# BCA COMPLIANCE ASSESSMENT REPORT

PROJECT: 461 Chapel Road, Bankstown  
REF. No.: NEW241003 (Rev 4)  
DATE: 27/02/2026  
CLIENT: Sustainable Development Group  
CONTACT: Richard Huynh  
EMAIL: richard.huynh@sdg.org.au  
CONSULTANT: Mauricio Vera  
PHONE No: 0451 078 790  
EMAIL: mvera@newcrown.com.au

### Nominated Exits and Associated Travel Distances

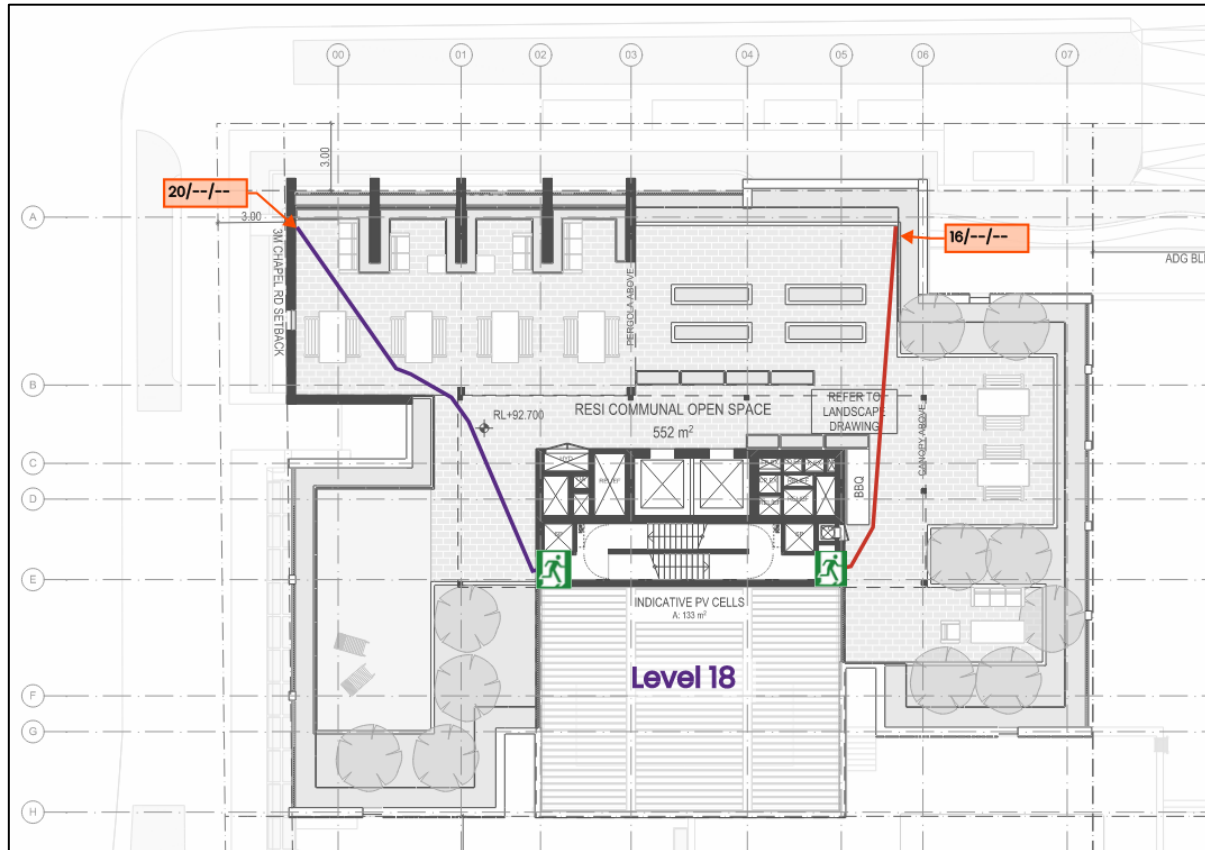
5.	Excessive travel distances to an exit: - Ground floor: 30m in lieu of 20m - Mezzanine: 28m in lieu of 20m - Levels 03-17: 9m in lieu of 06m - Level 17: 21m in lieu of 20m	Performance Solution	DIP4, E2P2	D2D5	TBC

Excessive travel distances to an exit and a point of choice are identified in various locations, in non-compliance with this clause. **To be rectified. Alternatively, Fire Engineer to assess and advise if a Performance Solution is feasible.**
